re: Geotechnical Recommendations - Grading Plan Review and Frost Protection
Proposed Warehouse Buildings
Campeau Drive at Huntmar Road
Ottawa, Ontario

file: PG6394-MEMO.02

Further to your request and authorization, Paterson Group (Paterson) prepared this memorandum to provide a review from a geotechnical perspective for the grading plan and landscaping plan for the proposed warehouse buildings at the aforementioned site. This memorandum should be read in conjunction with Paterson Group Report PG6394-1 Revision 3 dated May 31, 2023.

TREE PLANTING SETBACK RECOMMENDATIONS

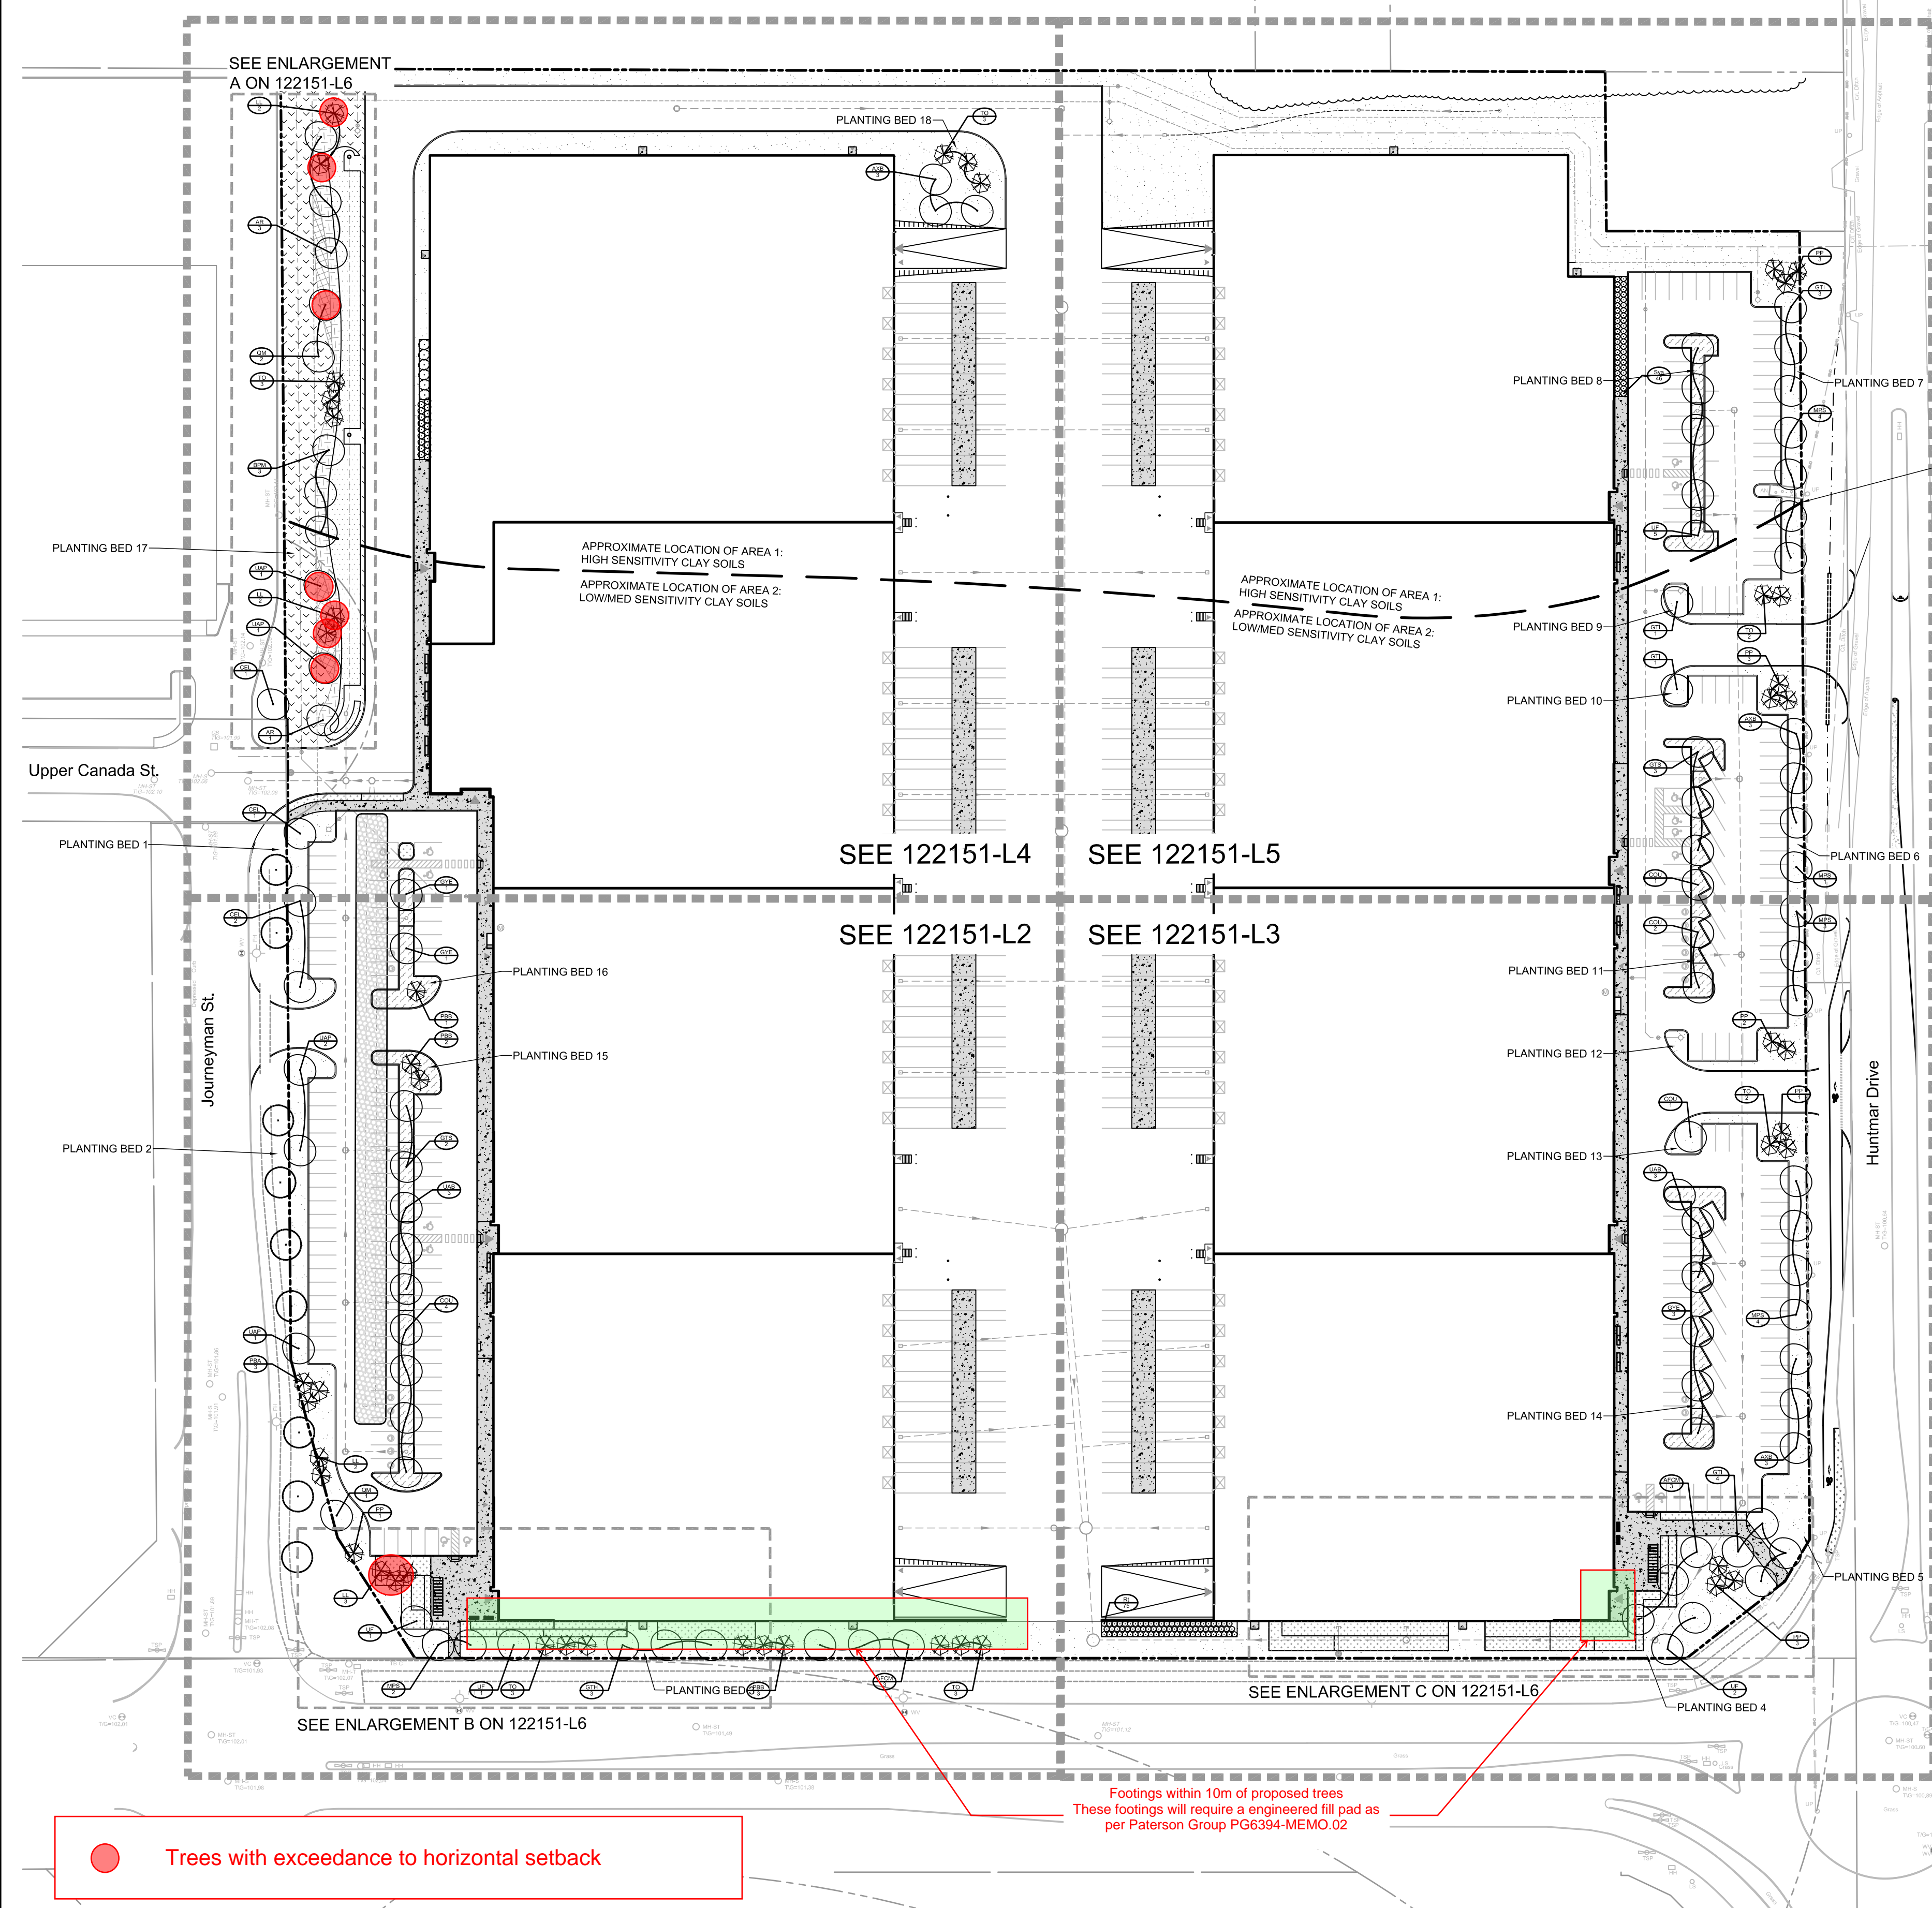
As noted in the above-mentioned geotechnical report, Atterberg limits testing was completed on selected samples at the subject site. Two tree planting setback areas are present within the proposed development and are outlined in the attached Drawing PG6394-2 - Tree Planting Setback Recommendations. The following general recommendation are required for Area 1 and Area 2:

Area 1- High Sensitivity Clay Soils:

The modified plasticity index results were generally greater than 40%, indicating a high sensitivity clay soil. Based on the test results and the City of Ottawa guideline "Tree Planting in Sensitive Marine Clay Soils - 2017 Guidelines," Large trees (mature height over 14 m) can be planted within this area provided a tree to foundation setback equal to the full mature height of the tree can be provided (e.g. in a park or other green space). The tree planting setback limits in Area 1 can be reduced to 7.5 m for small (mature tree height up to 7.5 m) and medium size trees (mature tree height 7.5 m to 14 m) provided that the following conditions are met:

Area 2 - Low/Medium Sensitivity Clay Soils:

The modified plasticity index results for this area were found to be less than 40%. This satisfies the first condition for reducing the tree foundation setback to 4.5 m in the City of Ottawa guideline “Tree Planting in Sensitive Marine Clay Soils - 2017 Guidelines.” The following conditions are also required to be met based on the tree planting guidelines:

DRAWING NAME
OVERALL LANDSCAPE PLAN

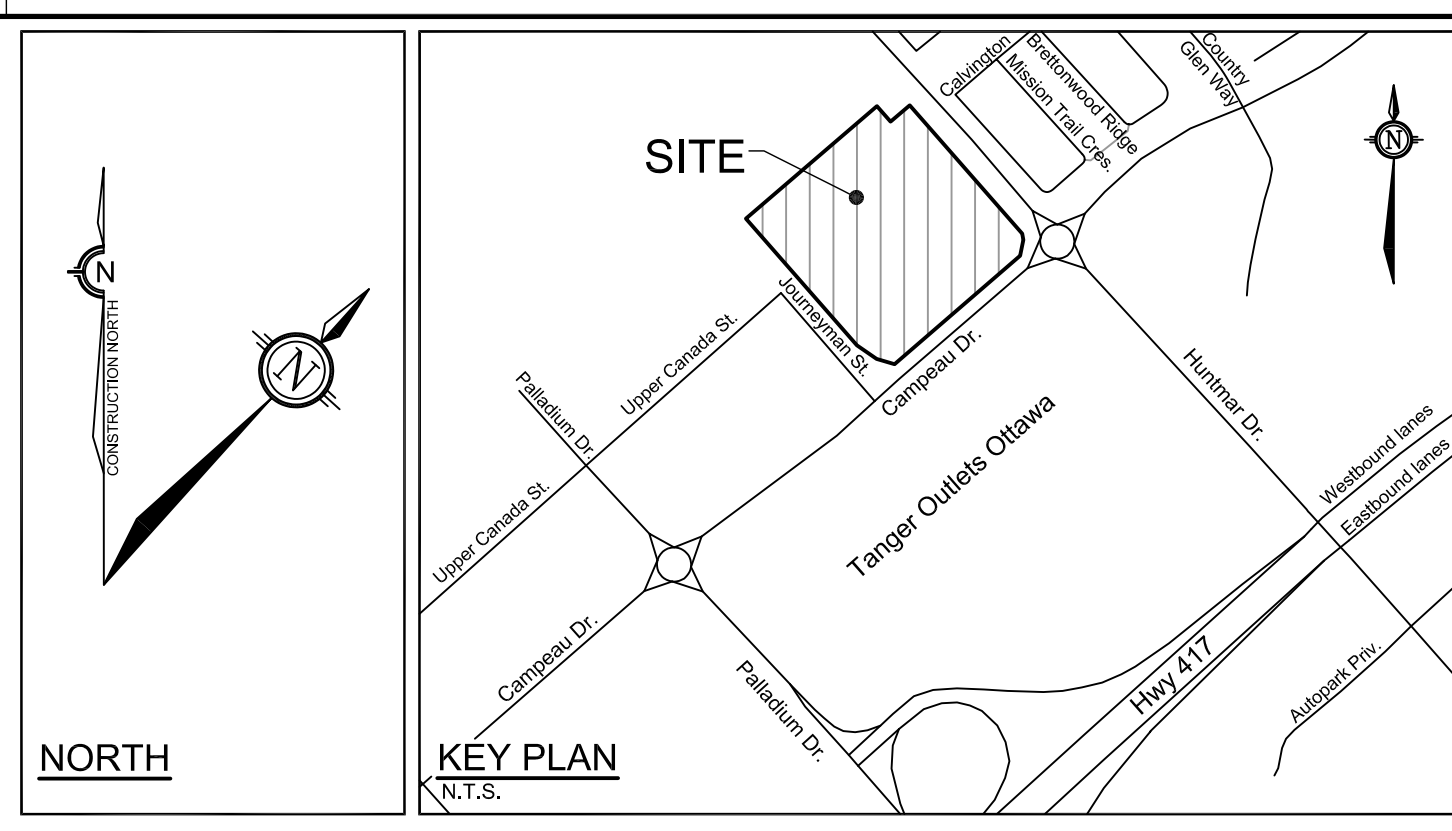
Based on our review of the above noted drawings, all footings were observed to have sufficient horizontal setback from proposed trees with the exception of some LL, UAP, and QM trees within buildings B1, B3, and B4, noted in the above table. These trees should either be sufficiently spaced from the building footprint at a minimum distance equal to the mature tree heights (20 to 30m) or should be replaced with small to medium trees with a maximum mature height of 14m.

Based on our review, it was further noted that the footings along the southern foundation wall of building B1 and the footings at the southeast corner of Building A1 will be located within 10m from the proposed trees, and therefore, will require to have a minimum embedment depth of 2.1m below finish floor elevation as per City guidelines for planting in sensitive marine clays. To compensate for the reduced foundation depth for the impacted footings, an engineered fill pad can be placed below the underside of footing to an elevation matching a depth of 2.1 m below proposed finished grade surrounding the buildings. The engineered fill pad will effectively increase the depth between the finished grade and the underlying silty clay deposit to the required 2.1 m which achieves the same goal as lowering the footing from a tree planting perspective. The granular pad should consist of OPSS Granular A or Granular B Type II placed in 300 mm loose lifts and compacted to 98% of the material's SPMDD. The granular pad should be extended horizontally a minimum of 150 mm beyond the footing edges in all directions and a minimum 1.5H:1V down and out from the footing face. Reference can be made to Figure 1 - Engineered Pad Below USF For Tree Planting Purposes attached for additional information.

Reference should be made to the attached markup drawing for the location of the effected footings.

Footings within 10m of proposed trees. These footings will require an engineered fill pad as per Paterson Group PG6394-MEMO.02

Trees with exceedance to horizontal setback

In addition, as required by the guidelines, the foundation walls should be provided with a minimum of two 15-M bars in the upper and lower sections of the foundation walls. This should be indicated on the relevant drawings and reviewed by Paterson at the time of construction.
